Re: Arizona Department of Environmental Quality 401 Certification for Rosemont Copper, Public Notice 27-14AZ LTF 55425

The additional comments provided herein largely pertain to that document, formally titled "Basis for State 401 Certification Decision, Rosemont Copper Project, ACOE Application No. SPL-2008-00816-MB". This document makes clear that ADEQ's draft certification has relied upon faulty information in the Final Environmental Impact Statement (EIS) and unsubstantiated opinions in documents that were provided by Rosemont Copper. Pima County and many others object to many of the conclusions of the Final EIS. Our previous review also found that ADEQ relied upon data and designs that no longer represent the mine as proposed to the US Army Corps of Engineers and the US Forest Service.

Additional Comments on State 401 Certification Decision – Rosemont Copper Project ACOE Application No. SPL – 2008-00816-MB

FIGURE 8. GRAPH OF DEUTERIUM VERSUS DELTA OXYGEN-18 FROM WELLS, SPRINGS, AND SURFACE WATER LOCATIONS, APRIL THROUGH OCTOBER 2008, ROSEMONT AREA

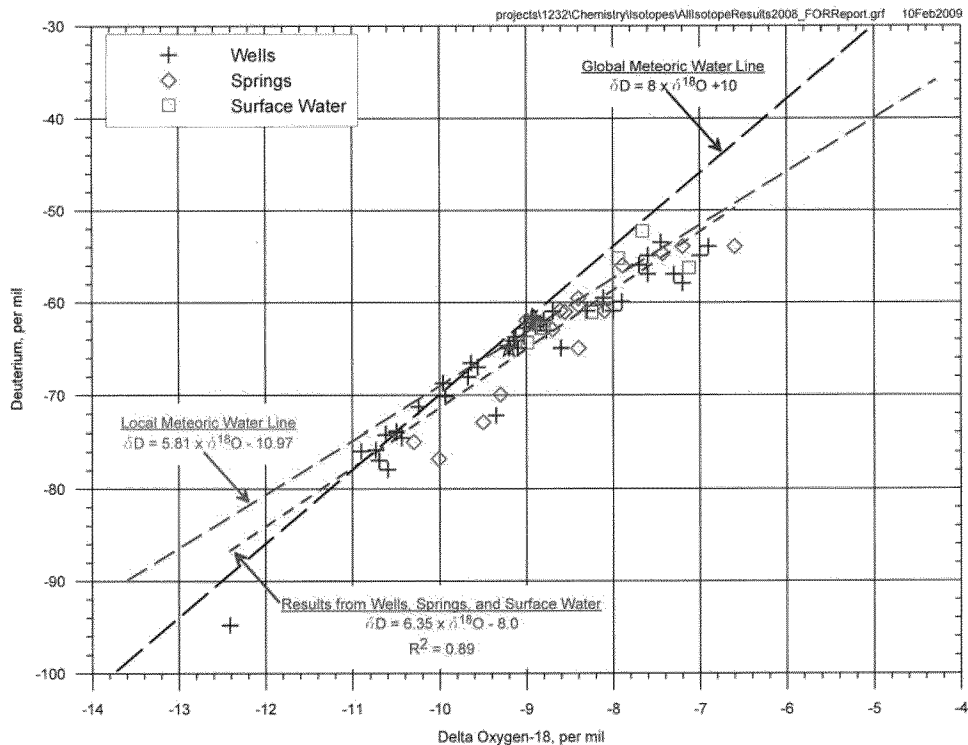
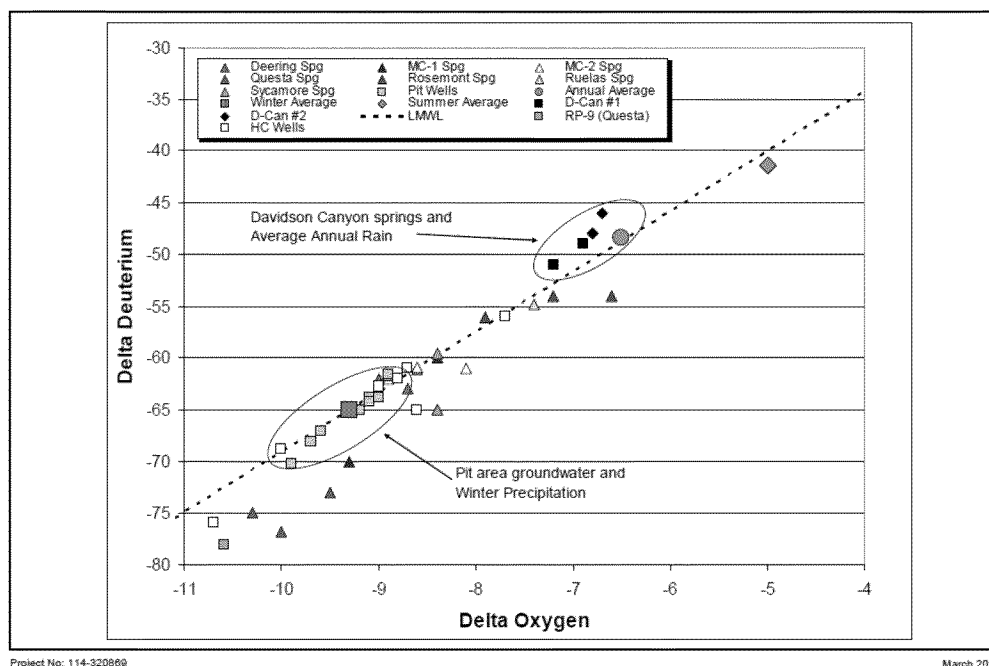
This is also shown graphically on Figure 8, Graph of Deuterium Versus Delta Oxygen-18 from Wells, Springs, and Surface Water Locations, April through October 2008, Rosemont Area (Montgomery and Associates, 2009). This figure is reproduced below. Wells are crosses. Note that the well delta oxygen values range from -12 to -7 on the horizontal scale. Note also that range of values for springs (diamonds) occupies nearly the same range, excepting the singular well value at RP-4B, which is a deep well screened in the Apache Canyon Formation.

4. Referencing Montgomery's Figure 8 again, note that all of the samples, even the PC wells, plotted below the Global Meteoric Water Line. This is not disclosed by Tetra Tech, and in fact the Tetra Tech plot actually obscures this fact by plotting a dashed line that does not represent the Global Meteoric Water Line. It can be seen that the intercept of Tetra Tech's line is much lower than the Global Meteoric Water Line that Montgomery shows. The slope of the local data, and the values of the PC wells considered as a group *both show substantial influence from natural evaporation during precipitation, runoff and / or recharge*, as was noted by Montgomery and Associates in their 2009 report. Tetra Tech did not discuss Montgomery's observation of an evaporative effect, presumably because it did not fit their preferred interpretation.

6. Figure 8 (Montgomery and Associates 2009) also has a local meteoric water line (LMWL) derived from data provided by Dr. Chris Eastoe. In attachment 3, Dr. Eastoe presents a more robust dataset for a LMWL. LMWL's are important because they provide a basis for interpreting sample results.

Tetra Tech Figure 17

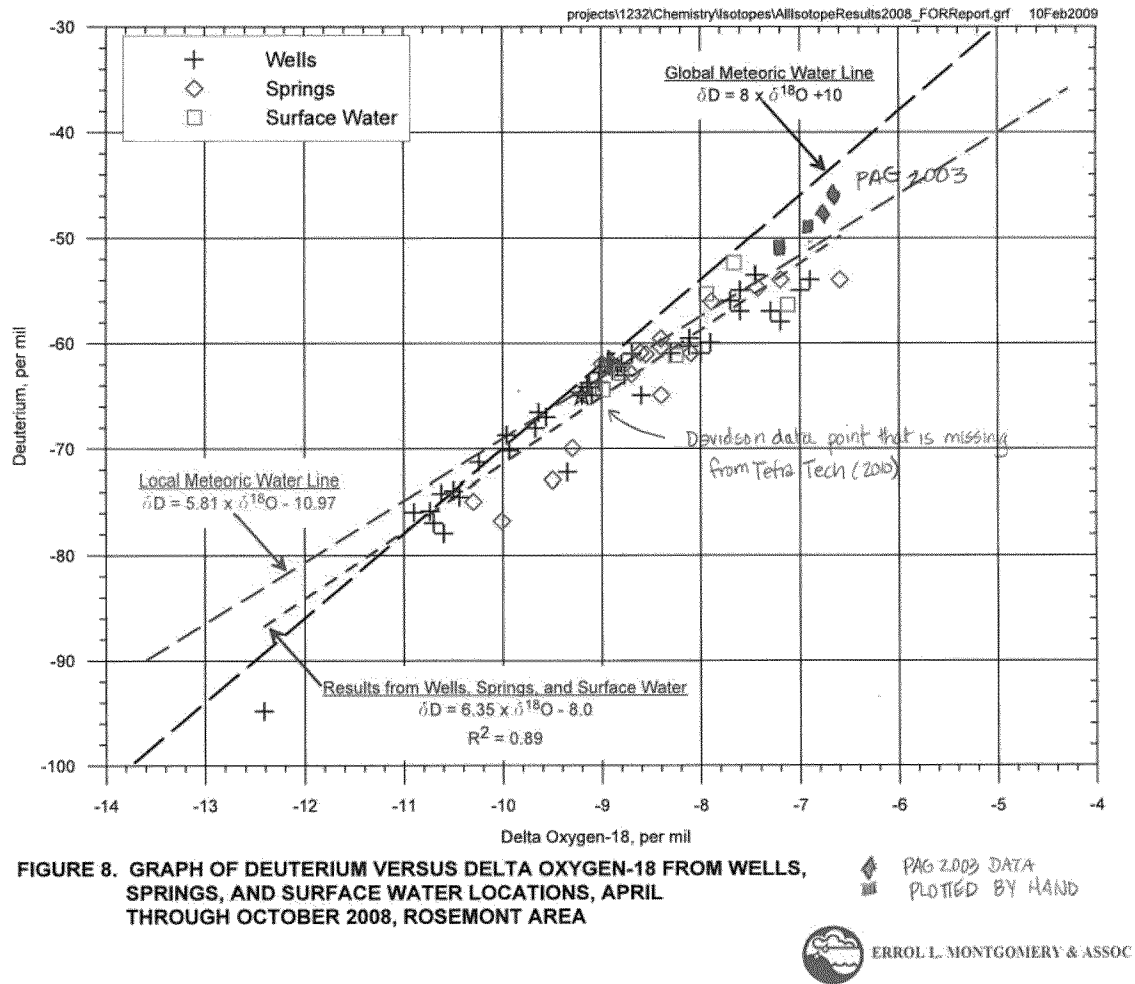
Some of these same data are shown on Figure 17 from Tetra Tech (2010), which differentiates the pit area groundwater (primarily PC well series) from other wells and springs in the mine vicinity. While it is true that the pit well data are largely grouped in the lighter oxygen values, many of Montgomery's other well and surface water data plot right along the red line calculated by Montgomery using the entire data set, suggesting that they are from the same population.

5. Tetra Tech's Figure 17 includes a data point representing winter average rainfall. This value is important because it is the principal basis for the inference that the position of the "*pit area groundwater*" on figure 17 means that *winter precipitation* is the source of the groundwater for the PC wells. Tetra Tech says that the winter average value is based on "stable isotope data for local precipitation" by Wagner (2006). Page 124 of Wagner 2006 provided several years of precipitation data from the vicinity of Cave of the Bells, in the Santa Rita mountains farther south. There were too few years in Wagner's sample to define a local meteoric water line (Dr. Chris Eastoe, personal communication).

10. Tetra Tech omitted well data that did not support their hypothesis. Tetra Tech's Figure 17 omits many of the wells and spring samples that plotted closer to the PAG dataset, but retained the "pit wells" that favored Tetra Tech's interpretation. The omitted samples that plotted closer to the PAG data set included wells RP-4A and RP-3A located in areas under the waste rock and tailings landform, and Rosemont spring, which would also be covered with waste rock and tailings.

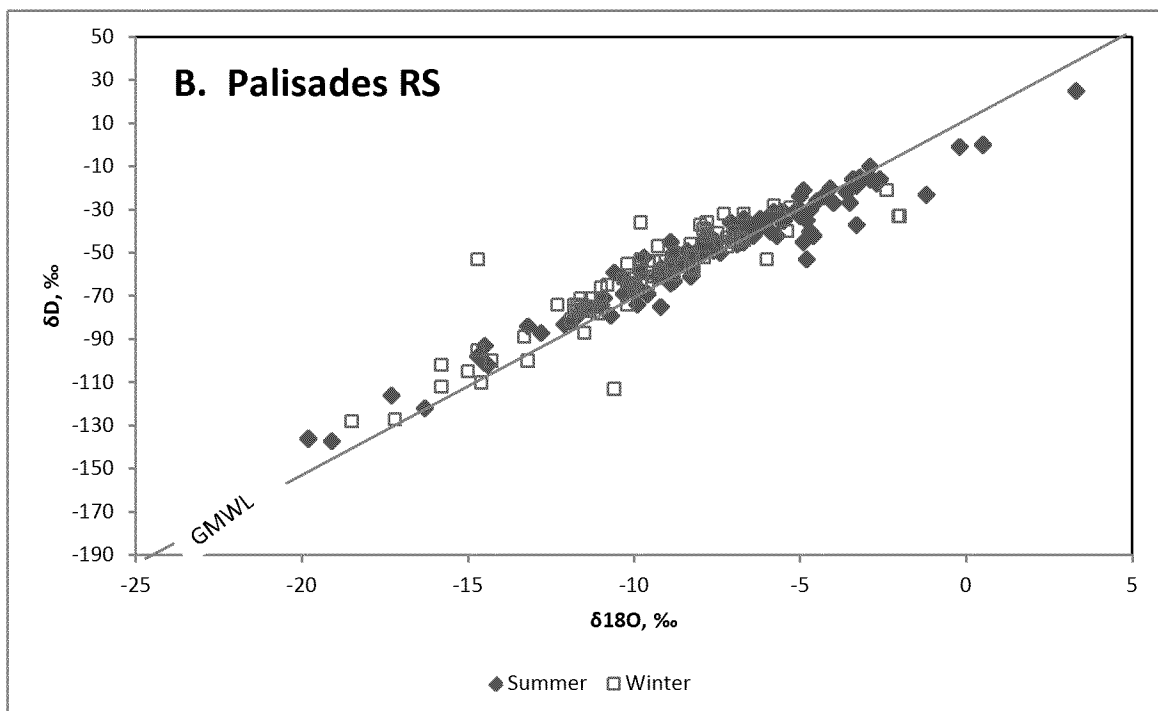
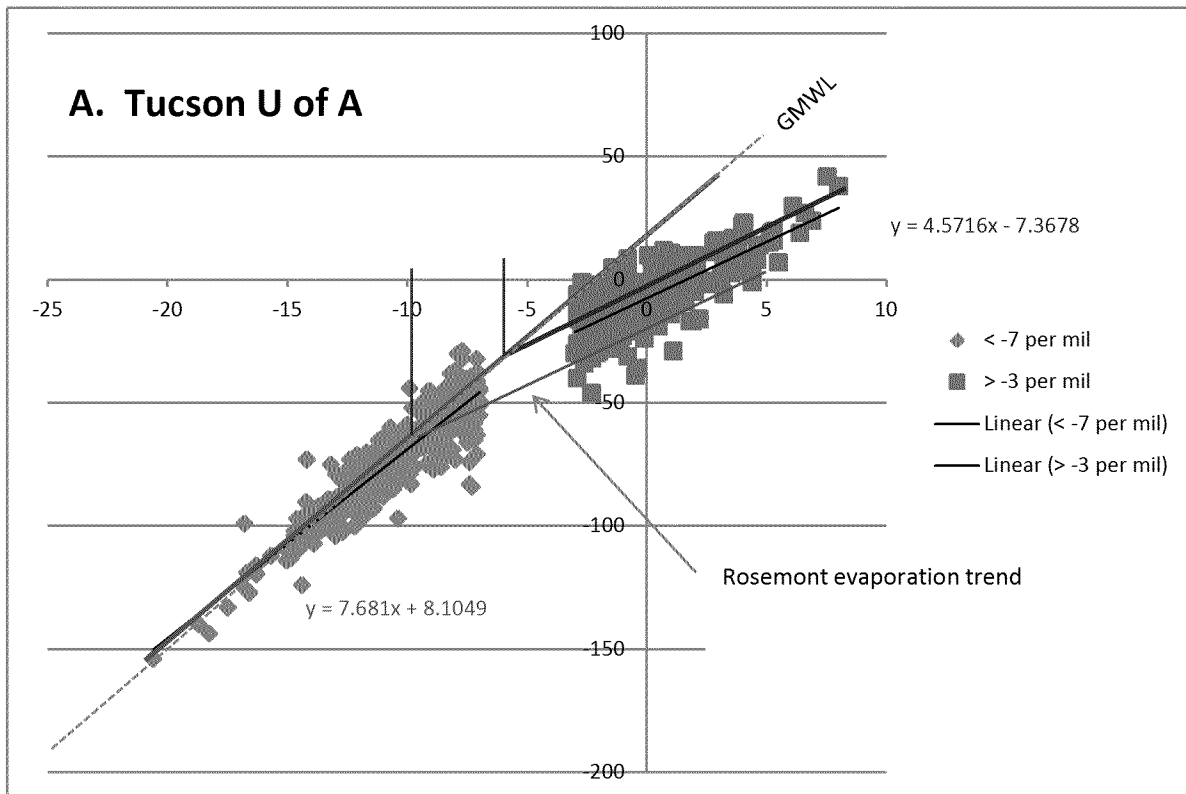
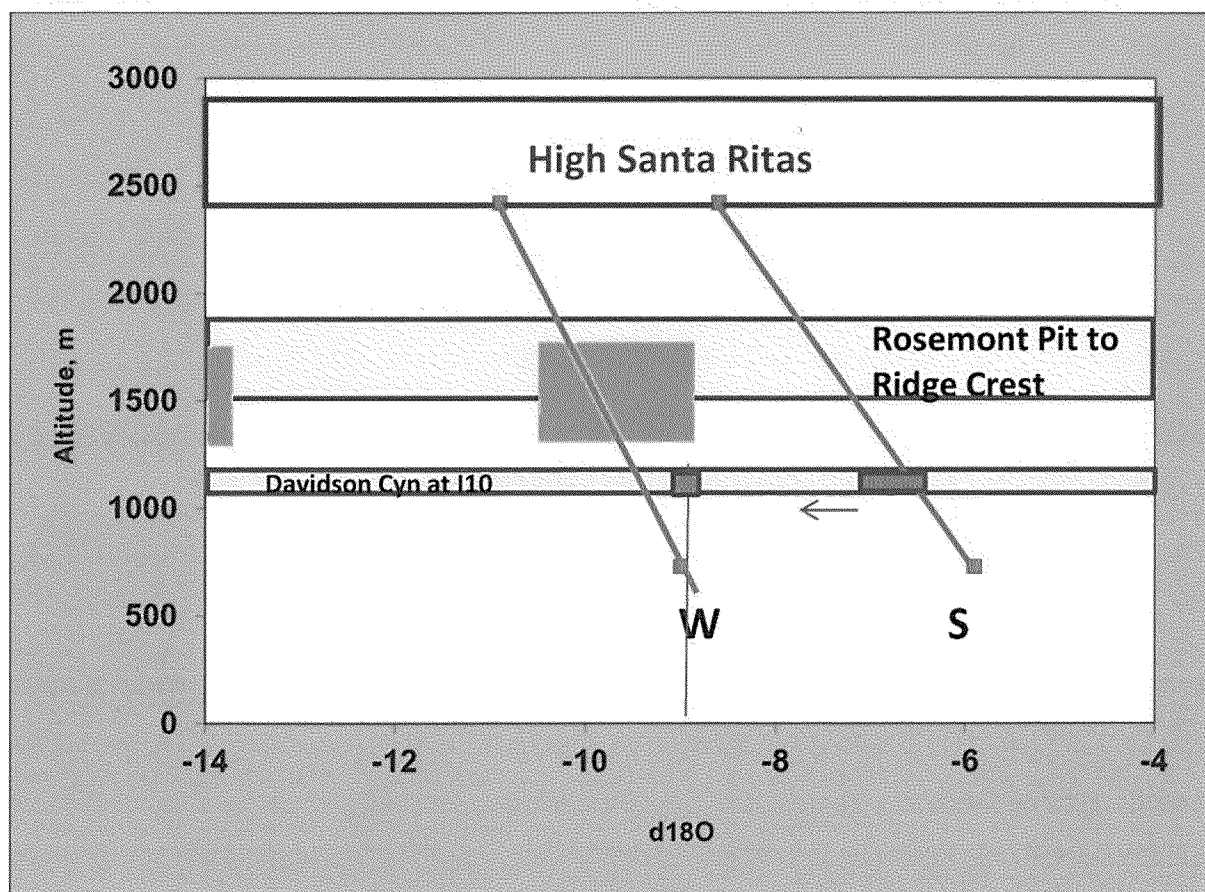
The isotope data for springs and wells in ELM's Figure 8 have been interpreted by ELM (2009) as a linear trend approximating a LMWL, the latter probably an inadequate estimate of the true LMWL(s) as suggested above. An alternative interpretation is that the data compose two trends: for $\delta^{18}\text{O}$ values < -9.5 ‰, a trend close to the GMWL for least evaporated samples, and for $\delta^{18}\text{O}$ values > -9.0‰, an evaporation trend of slope near 5 (Fig. 1A).

If the isotopic variation in precipitation in the Santa Rita Mountains resembles that in Tucson and the Santa Catalina Mountains, the intersection point near -9.5‰ does not reflect evaporation of falling rain. An alternative explanation for the isotope data is that infiltration of surface water with original (as precipitation) $\delta^{18}\text{O}$ values of -9.0 to -11.0‰ predominates. For -9‰, the recharge corresponds to mixed summer and winter precipitation, and for -11‰, to winter precipitation (Fig. 2). Infiltration of water that fell as rain with $\delta^{18}\text{O}$ values of long term average near -9.5 ‰ is common, accounting for more than half of the groundwater data points in ELM's Fig. 8. Evaporation of surface water prior to infiltration is also common, and evaporated versions of precipitation having $\delta^{18}\text{O}$ values of -9.0 to -14.0‰ are present in the data set. Precipitation with $\delta^{18}\text{O}$ > -9‰ does not appear contribute to recharge in a detectable quantity.
